SANDY SPRINGS

BOARD OF APPEALS

Wednesday, February 4, 2026

- A. **2026-0002 V-25-54 - 701 Bass Way** — Request for a Variance from Sec. 6.1.2.B. to allow the encroachment of a building eave into the 30- foot side street setback.
(Presented by Helen Owens, Planner III/Zoning Administrator)
- B. **2026-0003 V-25-53 – 870 Edgewater Drive** – Request for a Variance from Sec. 6.1.2.B. to encroach into the 60- foot primary street setback by 20 feet for a new home.
(Presented by Helen Owens, Planner III/Zoning Administrator)
- C. **2026-0004 V-25-60 – 4825 Franklin Pond Road** – Request for a Variance from Sec. 11.7.2.B.3., and Sec. 6.1.2.B. to expand and alter nonconforming structures in the 35-foot rear setback and 50- foot primary street setback.
(Presented by LaQuita Williams, Planner II)

Variance Request

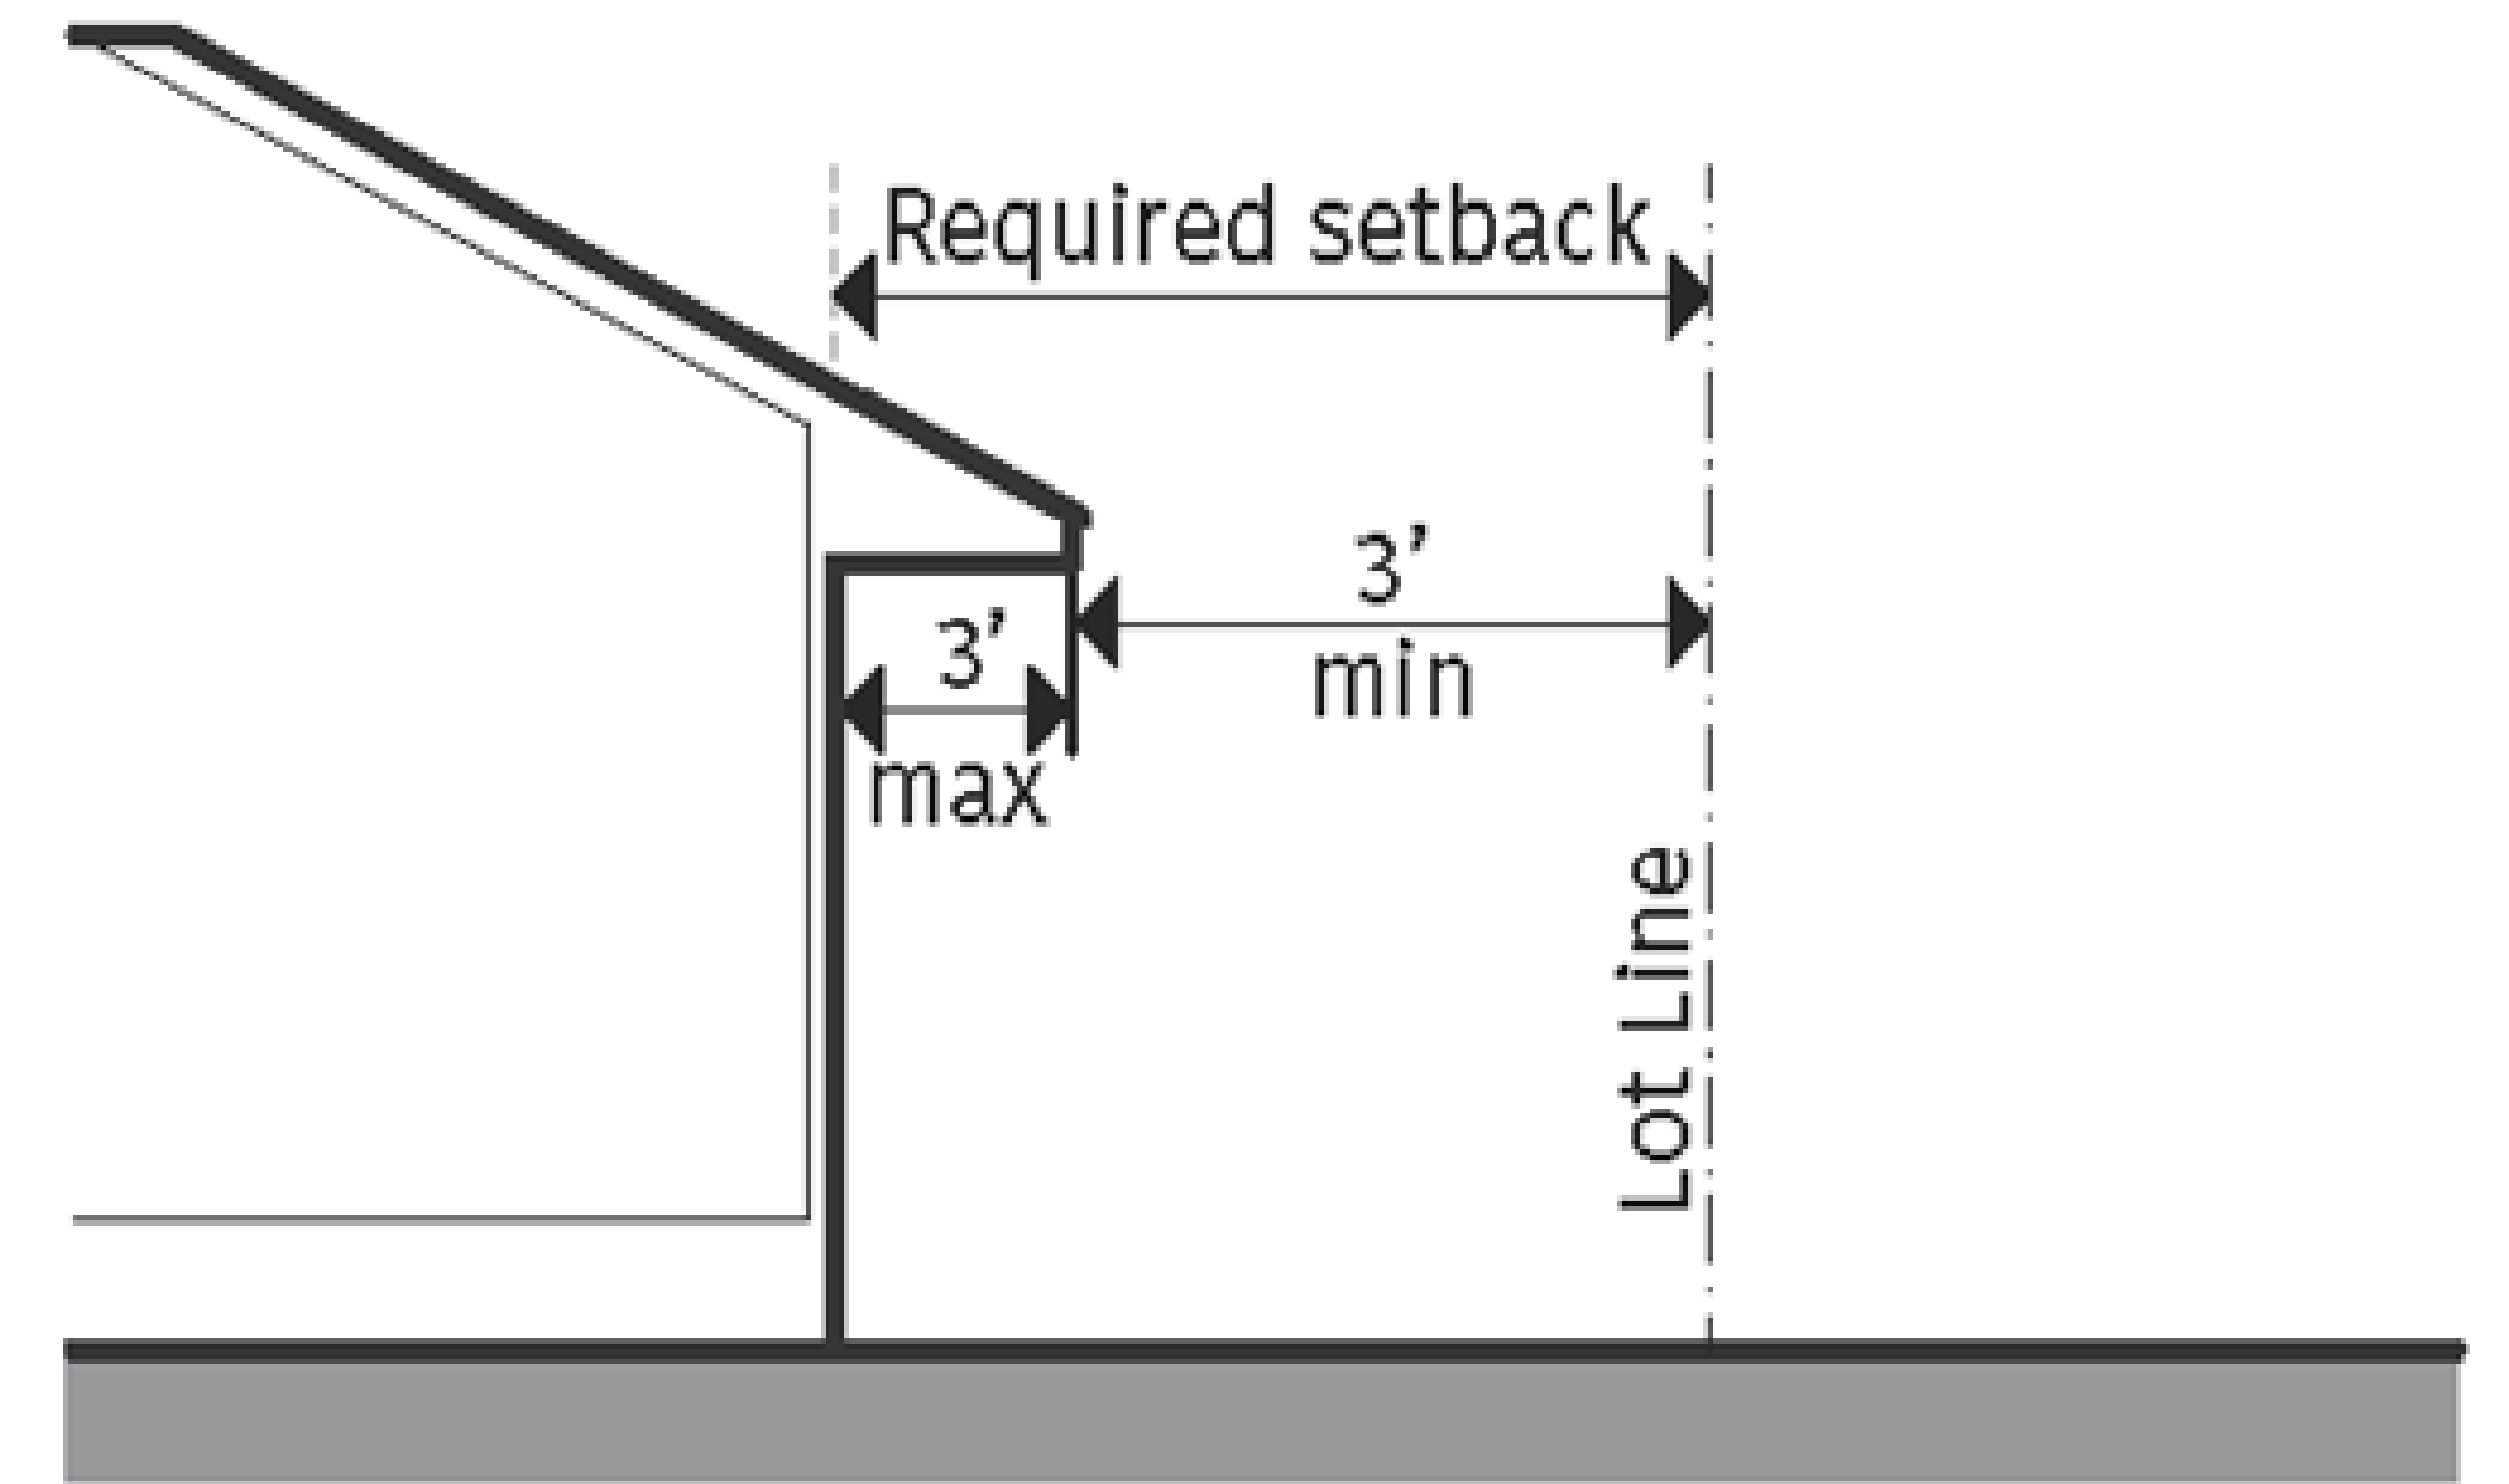
- The applicants are proposing to retain an 5.2-foot building eave that encroaches into the 30-foot side street setback on the North side of the property. The eave is part of an addition that includes a 330 square foot patio, fire place, and steps on the north side of the home. Evergreens and additional landscaping screen the entire northern street side of the home blocking any view of the eaves from Mount Vernon Hwy.
